VIRGINIA ELECTRIC AND POWER COMPANY (DOMINION)
SURRY AND NORTH ANNA POWER STATIONS UNITS 1 AND 2
REQUEST FOR ADDITIONAL INFORMATION – RE: STATION BLACKOUT AND
NON-EQ CABLE MONITORING PROGRAM
LICENSE RENEWAL APPLICATIONS

**License Renewal – Revised Response to RAI 2.5-1
Serial No. 02-297**

**Surry and North Anna Power Stations, Units 1 and 2
License Renewal Applications**

**Figure SPS-1
 Surry Power Station**

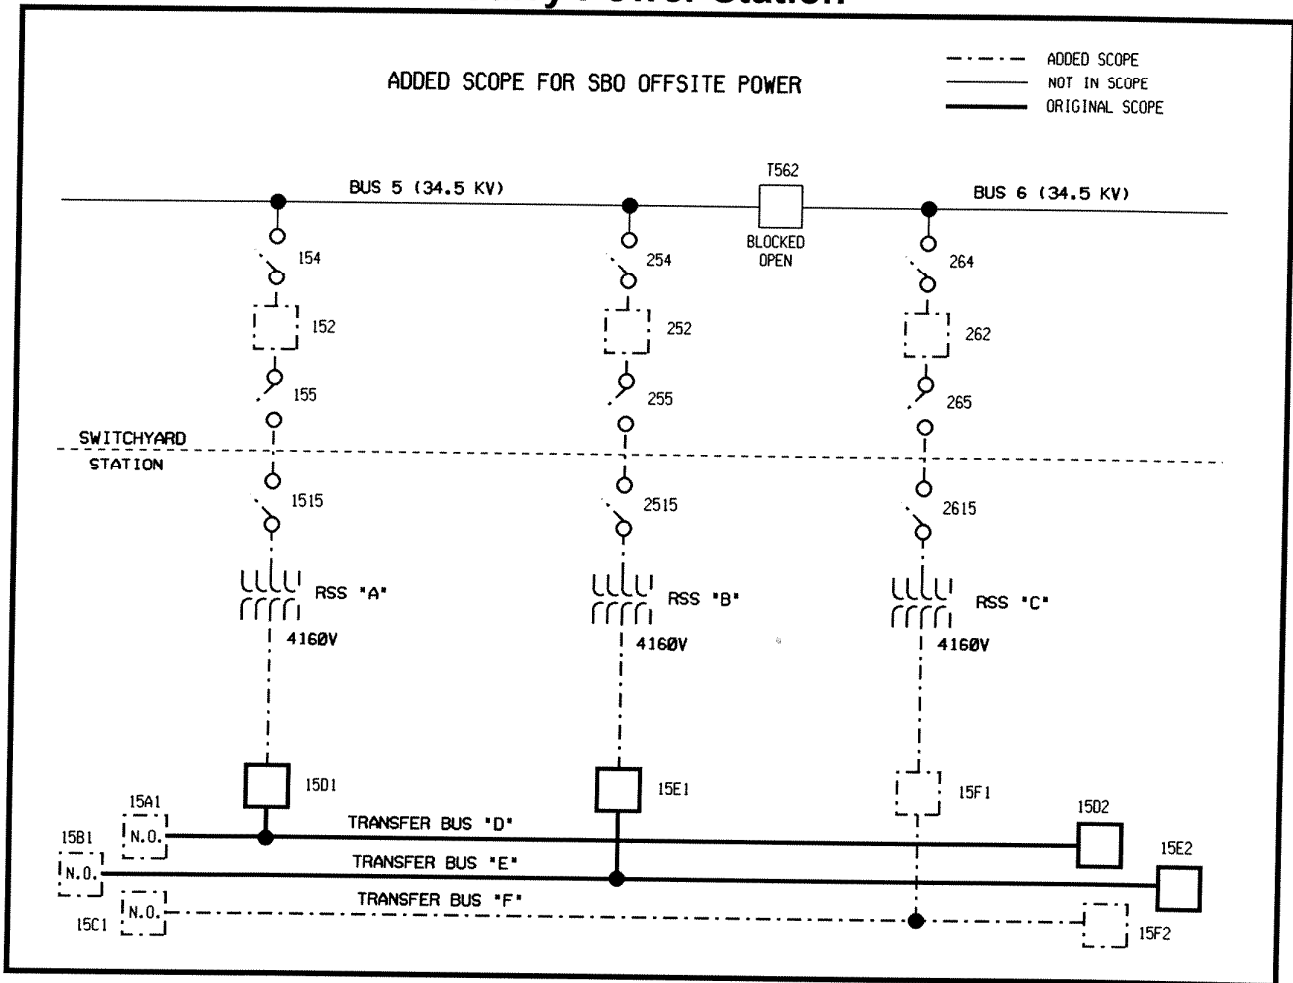
For Surry, the additional offsite power path scope required to recover from an SBO event extends from the switchyard disconnect switches through the 34.5KV circuit breakers to the RSSTs and continues to Transfer Buses D, E, and F. Transfer Buses D and E and their associated 4160V circuit breakers and controls are already within the SBO equipment scope of license renewal. Figure SPS-1 provides an excerpt from the Surry one-line integrated schematic electrical drawing and shows the boundary of the additional SBO offsite power path scope.

**Figure NAPS-1
 North Anna Power Station**

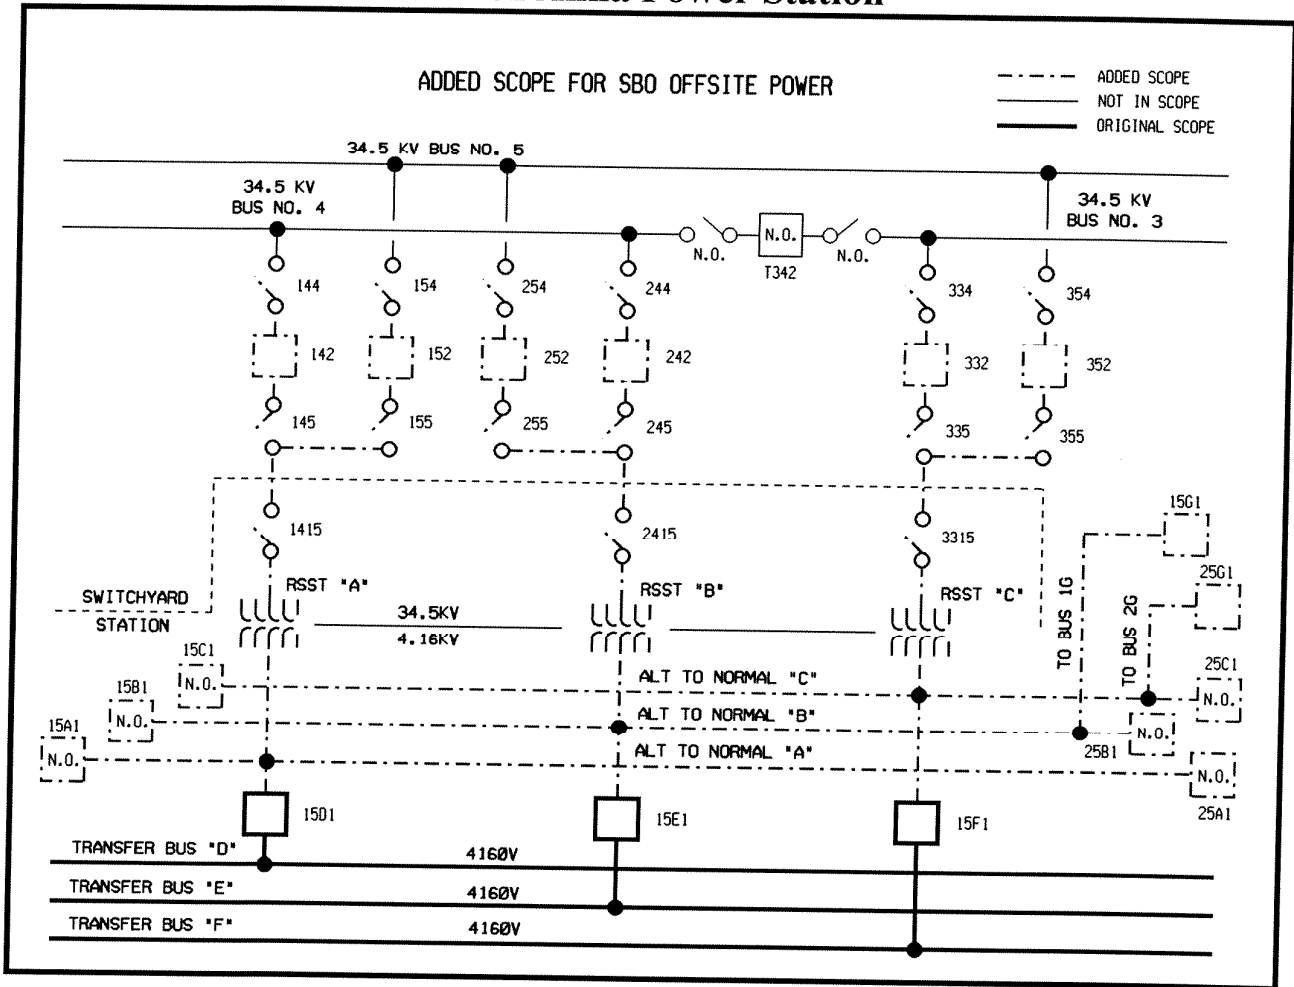
For North Anna, the additional offsite power path scope required to recover from an SBO event extends from the disconnect switches through the 34.5KV circuit breakers to the RSSTs and continues to the line side of the 4160V circuit breakers which connect the RSSTs to the Transfer Buses D, E, and F. The aluminum tube buses and cabling which connect the RSSTs to the normal station service buses A, B, C, and G are not required for restoration of offsite power following an SBO event. However, this portion of the North Anna electrical distribution system can not be isolated from the required power path and, therefore, is included in the additional SBO scope for license renewal. Transfer Buses D, E, and F and their associated 4160V circuit breakers and controls are already within the SBO equipment scope of license renewal. Figure NAPS-1 provides an excerpt from the North Anna one-line integrated schematic electrical drawing and shows the boundary of the additional SBO offsite power path scope.
